SUBJECT: DRAFT ENVIRONMENTAL ASSESSMENT COMMENTS ON YUCCA MOUNTAIN CONCURRED  
ON BY BEN RICE

EA/YUCCA MT/MAJOR COMMENTS

YUCCA MOUNTAIN MAJOR COMMENTS

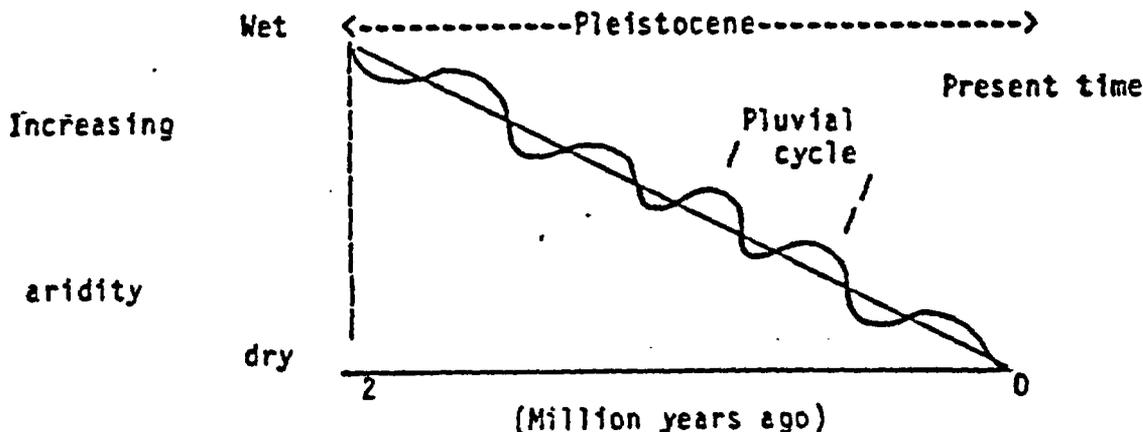
Same paragraph, last two sentences—No contradiction is present. "Winograd and others (1985)" are talking about a long term of increasing aridity through the Quaternary, whilst the Lahonton record is simply one of superimposed pluvials. See sketch.

Page 6-196, paragraph 1, complete - Change the two references to "Winograd and Doty (1980)," to "Winograd and others (1985)." While the reference to "Winograd and Doty (1980)" is correct elsewhere in the EA, in this paragraph it is incorrect. That is, "Winograd and Doty (1980)," do not discuss uplift of the Sierras as responsible for increasing aridity during the Quaternary; but, "Winograd and others (1985)" indeed do so. The new reference is: Winograd, I. J.; Szabo, B. J.; Coplen, T. B.; Riggs, A. C.; and Kolesar, P. T.; 1985, Two-million-year record of deuterium depletion in Great Basin ground waters: Science, v. 227, pp. 519-522.
